Watts Bar Nuclear Plant, Unit 1
Facility Operating License No. NPF-90
NRC Docket No. 50-390

Watts Bar Nuclear Plant, Unit 2
Construction Permit No. CPPR-92
NRC Docket No. 50-391

Subject: **Response to NRC Request for Additional Information Related to Overall Integrated Plan in Response to the Commission Order Modifying Licenses with Regard to Requirements for Reliable Spent Fuel Pool Instrumentation (Order Number EA-12-051) (TAC Nos. MF0951 and MF1178)**

**RESPONSE TO NRC REQUEST FOR ADDITIONAL INFORMATION
RELATED TO OVERALL INTEGRATED PLAN IN RESPONSE TO THE COMMISSION
ORDER MODIFYING LICENSES WITH REGARD TO REQUIREMENTS FOR
RELIABLE SPENT FUEL POOL INSTRUMENTATION**

POOL LEVELS AND REFERENCES

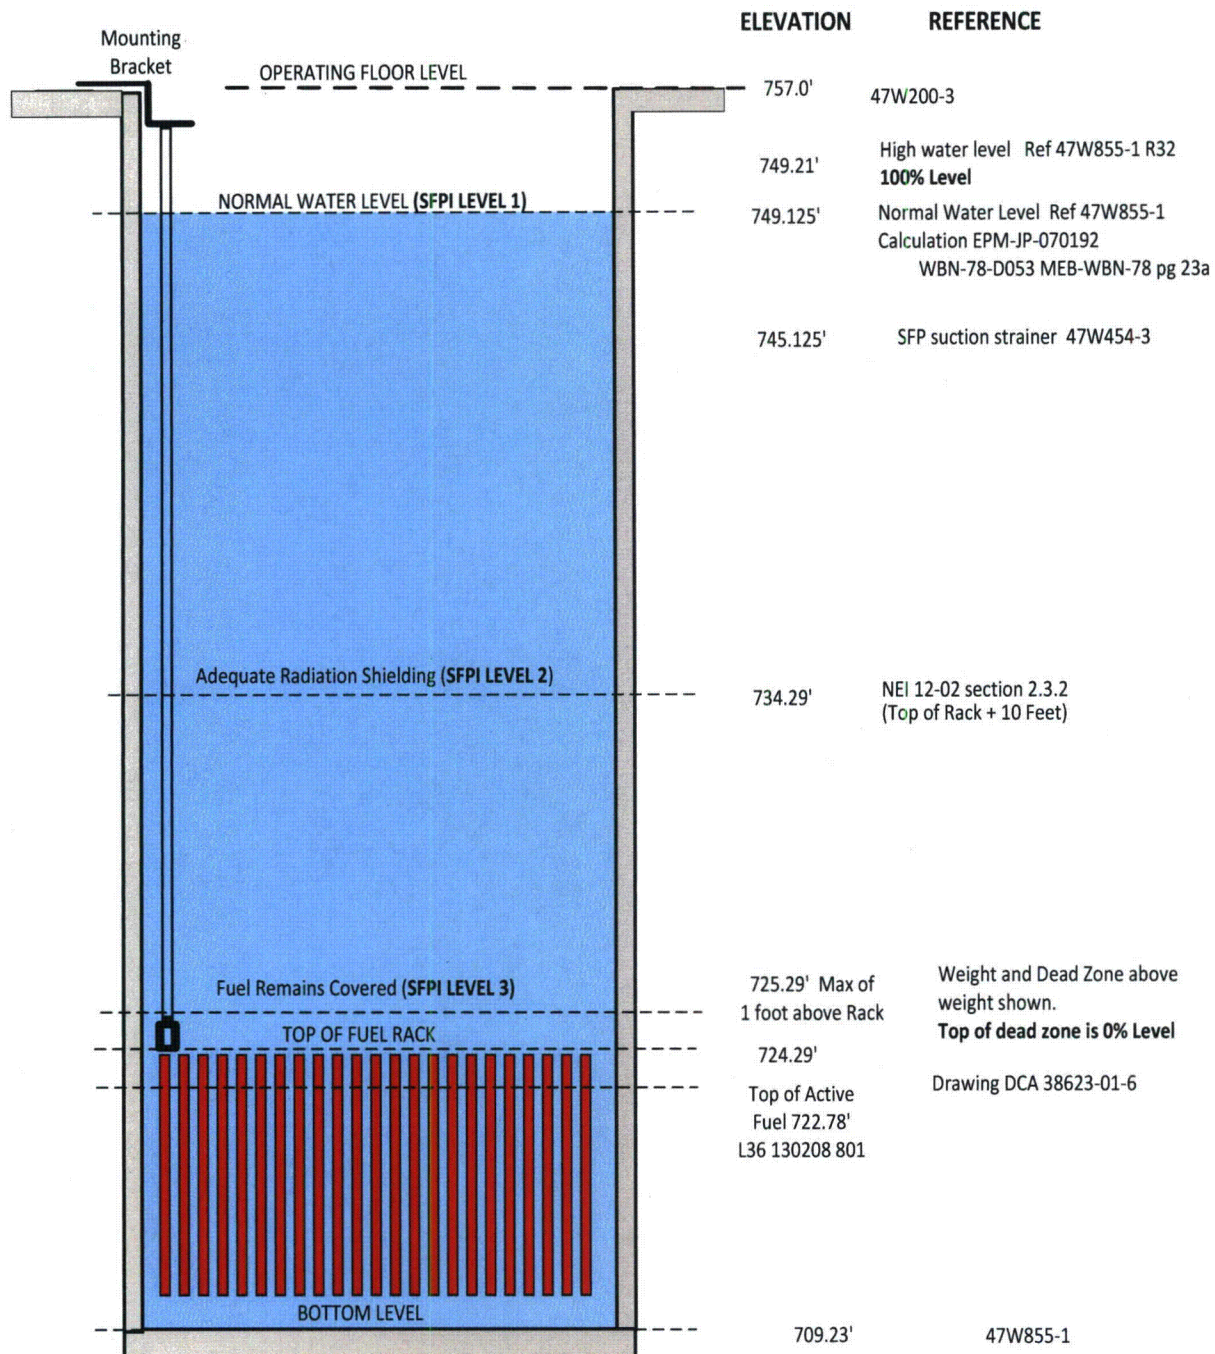
- a) *The specific elevations within the SFP as Levels 1, 2 and 3. For Level 1, specify how the identified location represents the HIGHER of the two points described in the NEI 12-02 guidance for this level.*
- b) *A clearly labeled sketch depicting the elevation view of the proposed typical mounting arrangement for the portions of instrument channel consisting of permanent measurement channel equipment (e.g., fixed level sensors and/or stilling wells, and mounting brackets). Indicate on this sketch the datum values representing Level 1, Level 2, and Level 3 as well as the top of the fuel. Indicate on this sketch the portion of the level sensor measurement range that is sensitive to measurement of the fuel pool level, with respect to the Level 1, Level 2, and Level 3 datum points.*

- a) The specific elevations corresponding to the three levels are indicated on the sketch on page E1-3. TVA will use the normal spent fuel pool water level at WBN (749.125 feet) as Level 1. The normal spent fuel pool water level is higher than the coolant inlet pipe that is at elevation 745.125 feet. This complies with NEI 12-02 requirements as outlined below:

- b) The Guided Wave Radar system can only sense level changes above the weight and there is a small distance above the weight that the manufacturer defines as the dead zone. Preliminary discussions with the manufacturer have indicated that the total distance above the SFP rack where level changes cannot be detected is less than one foot. The exact distance has not been specified at this point. A sketch for Spent Fuel Pool Level is shown on page E1-3 which shows the locations of Levels 1, 2 and 3; the instrument full span range and top of fuel rack. The space shown below Level 3 and

above "Top of Fuel Rack" is the area where level changes would not be detected. TVA will utilize the Top of the dead zone as Level 3 instead of Top of Fuel Storage Rack.

Route from Main Control Room to Electric Board Room

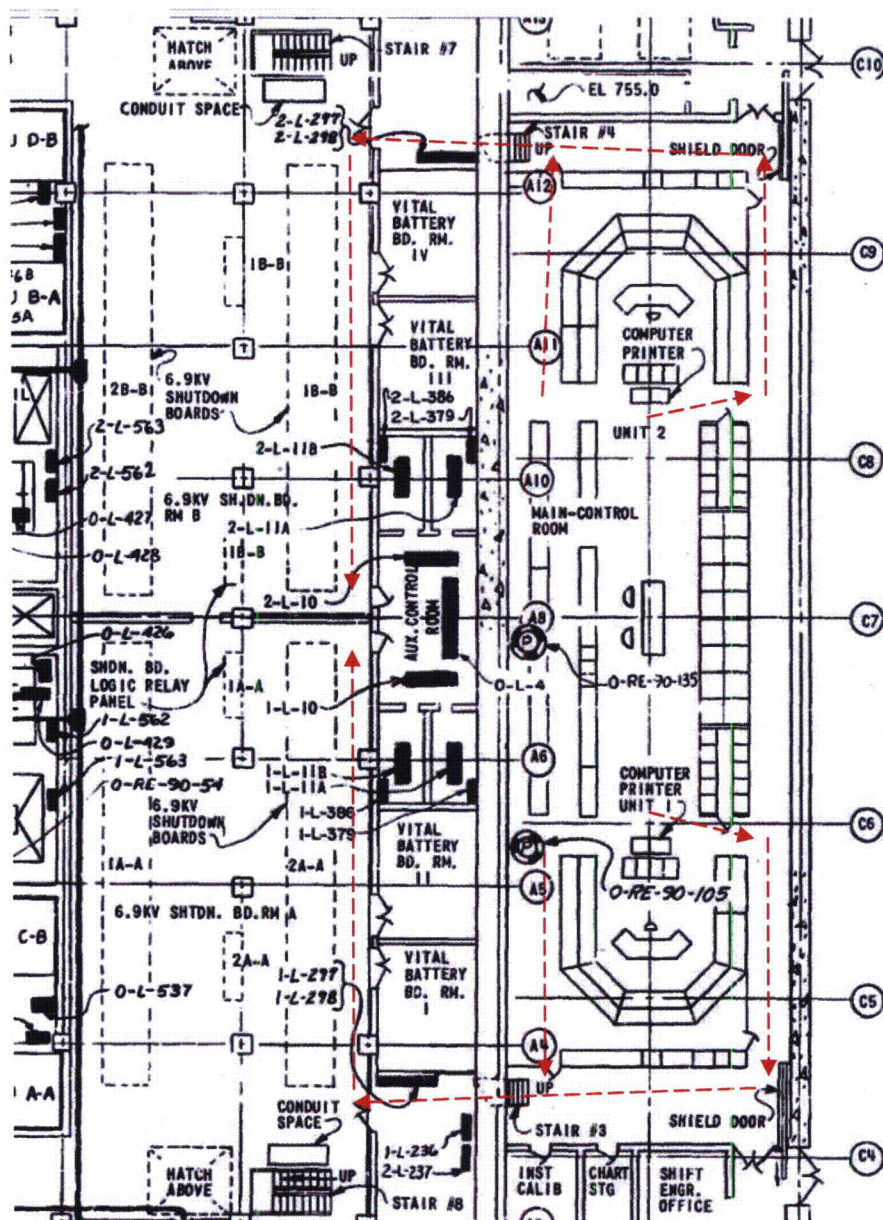
- a) Since one of the display locations is not in the main control room, provide a description of the display location that addresses primary and alternate access route evaluation, continuous habitability at display location(s), continual resource availability for personnel responsible to promptly read displays, and provisions for verbal communications with decision makers for the various SFP drain down scenarios and external events.*
- b) The reasons justifying why the location selected will enable the information from these instruments to be considered "promptly accessible". Include consideration of various drain-down scenarios.*

- a) WBN SFP is shared between both units and will have a total of two level instrument channels. One instrument channel display will be located in the Main Control Room. Engineering for the SFPI Level channels is in progress; however, the exact location for the battery pack/display enclosure for both channels has not yet been determined. The second instrument channel display is anticipated to be located in the Electric Board Room which is in close proximity to the Auxiliary Control Room. The Electric Board Room is a mild environment, is promptly accessible (2 minute walk) by main control room personnel and is not subject to the environmental conditions associated with boiling in the SFP. Communications by radio or telephone is available if needed. The route to the Electric Board Room/Auxiliary Control Room area from the Main Control Room will be the same route that is utilized during design basis events because the route is within a safety related, seismic structure. The pathway is expected to remain intact following a seismic event. See the sketch below for the route from the Main Control Room to the Electric Board Room.

- b) The Electric Board Room is in a mild environment, is promptly accessible (2 minute walk) by main control room personnel. Therefore, the environment is not affected by the environmental conditions associated with any drain down scenario.
